Roland Water Tower Park
Maryland Historic Trust
Historic Preservation Easement Program
Change/Alteration Request Application
July 28, 2021 Support Materials

Project Narrative

LANDSCAPE SURFACE DEMO +
PROTECTION PLAN

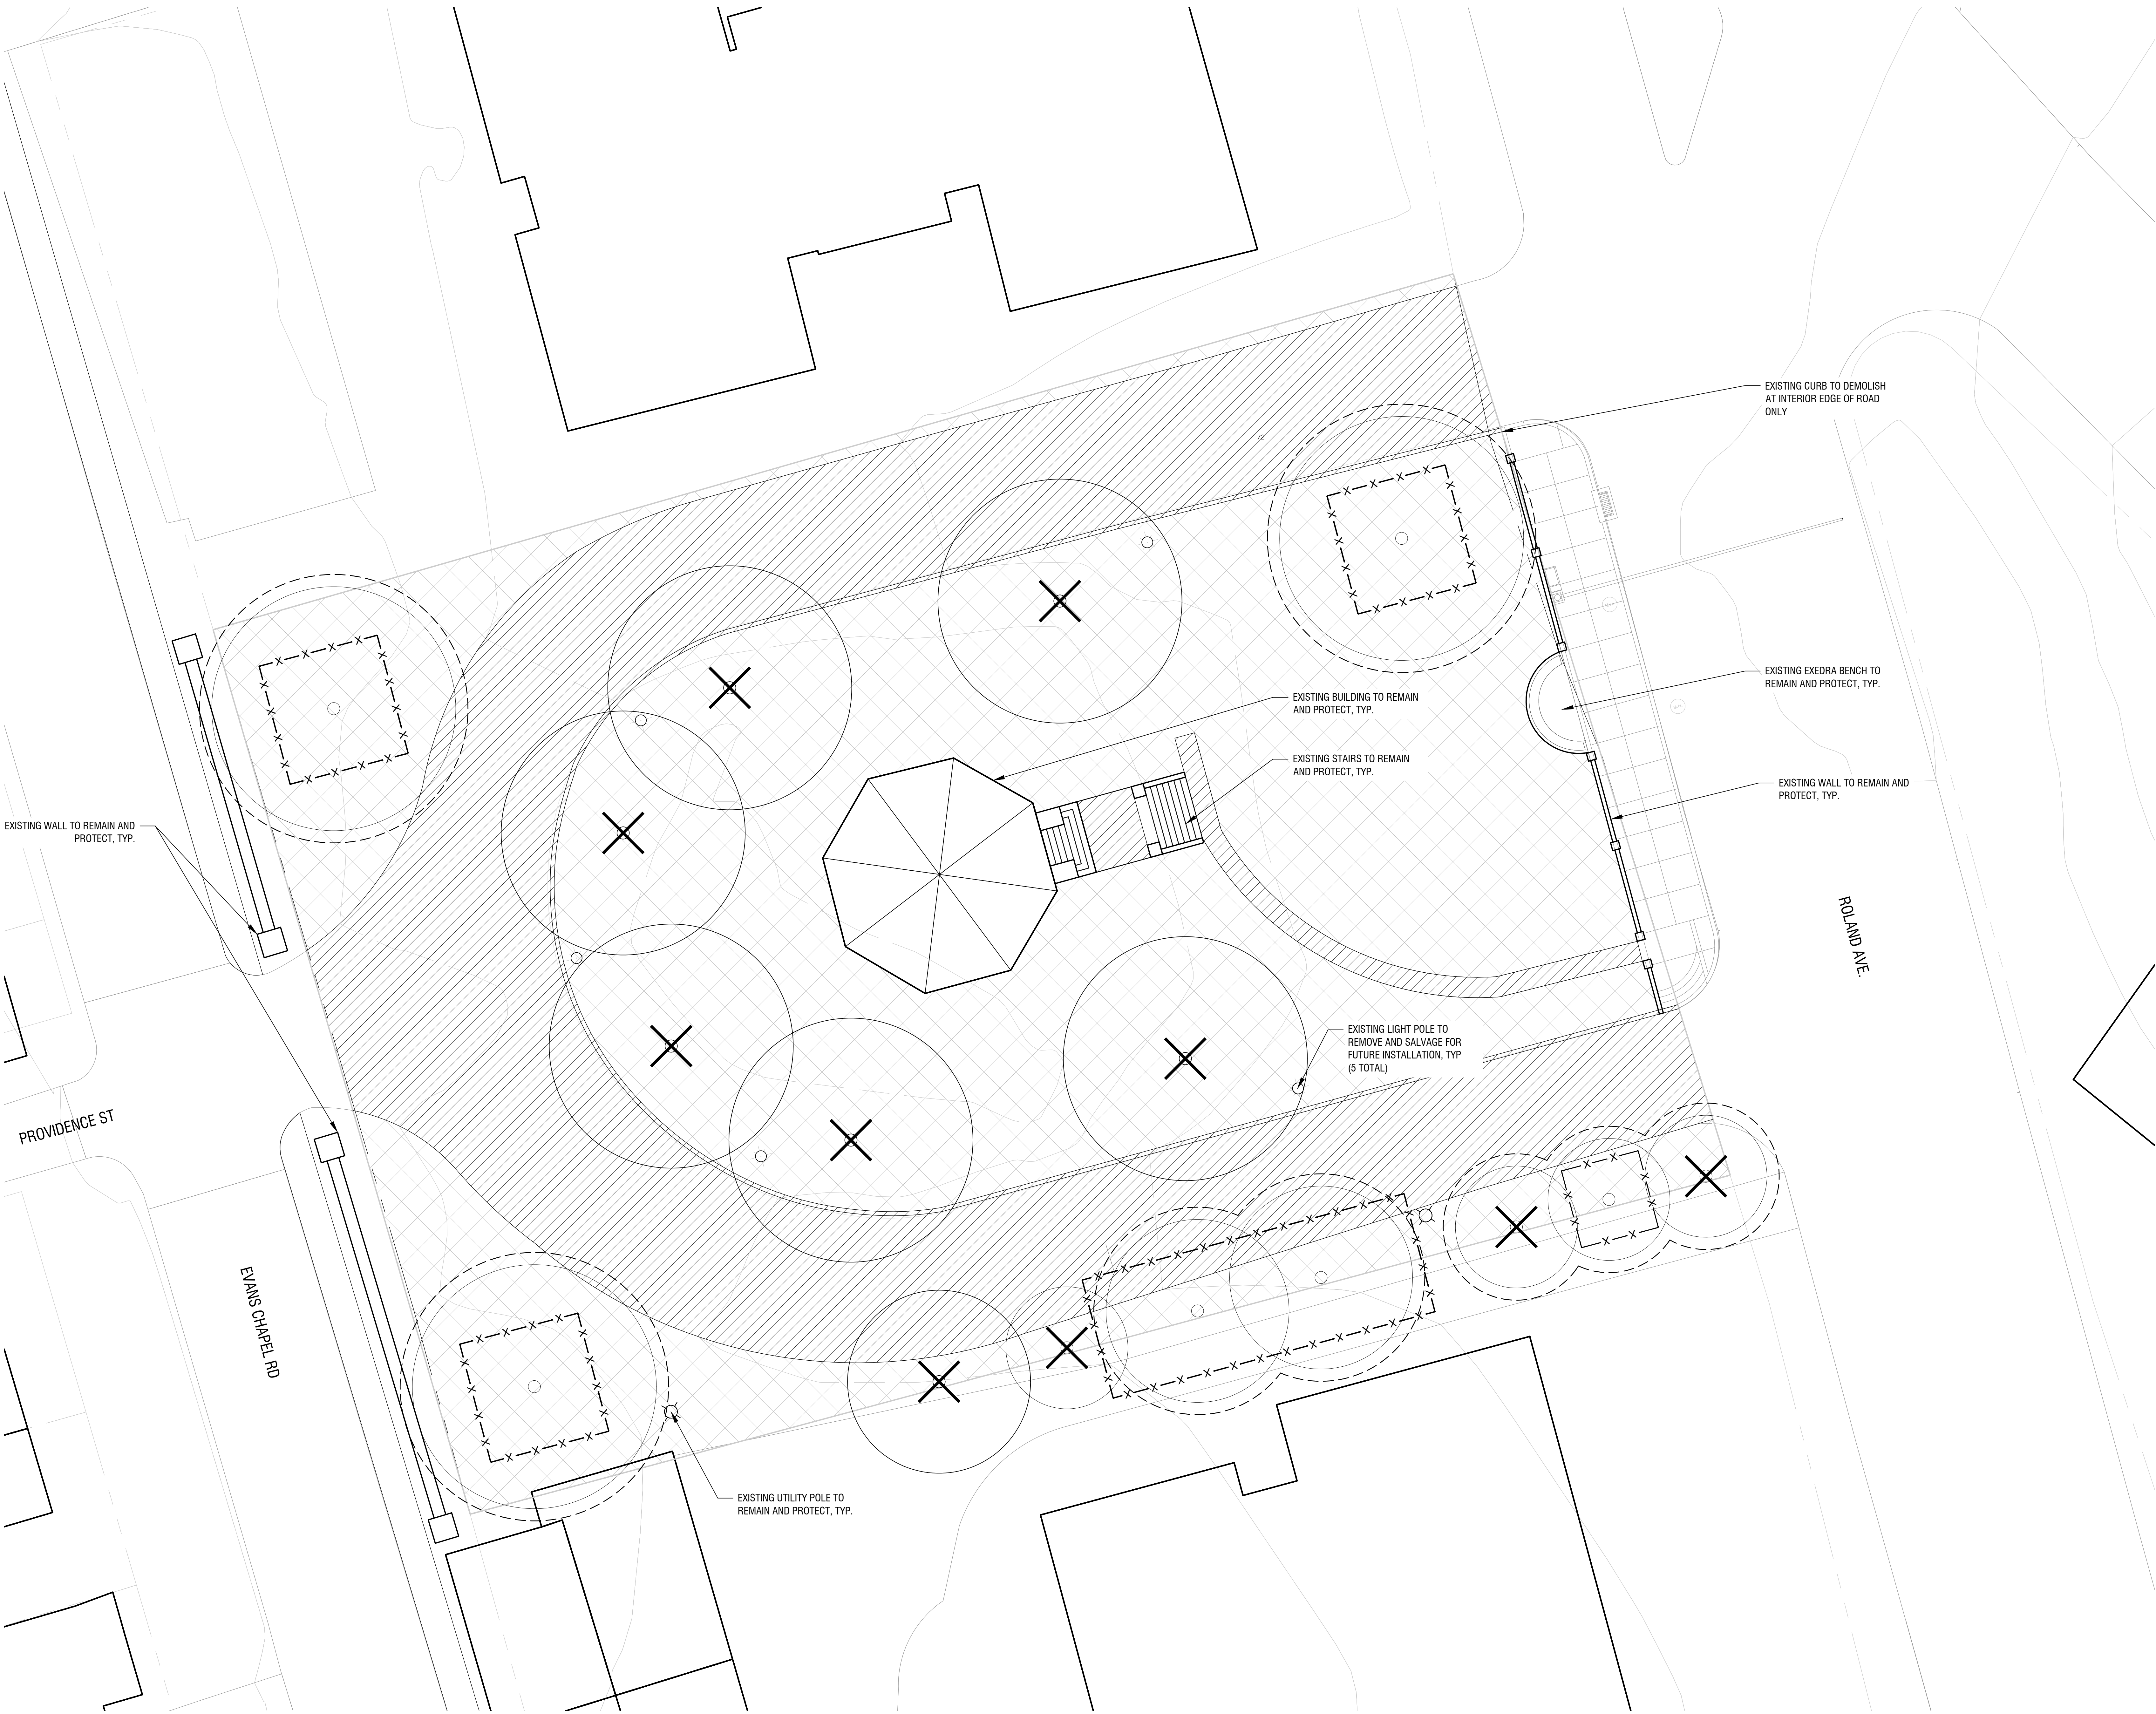
- DEMOLITION AND PROTECTION PLAN
CORRESPONDS TO FULL VISION, L-000
DRAWING.
- CLEAR, GRUB AND GRIND STUMP TO
DEPTH REQUIRED IN ORDER TO INSTALL
FINISH MATERIAL AS SHOWN IN
DRAWINGS. BACKFILL ALL PITS.
- CLEAR AND GRUB ALL AREAS TO
RECEIVE PLANTING.
- REMOVE ALL INVASIVE PLANTING
- SPECIAL EXCAVATION REQUIRED AT
EXISTING TREES TO REMAIN.
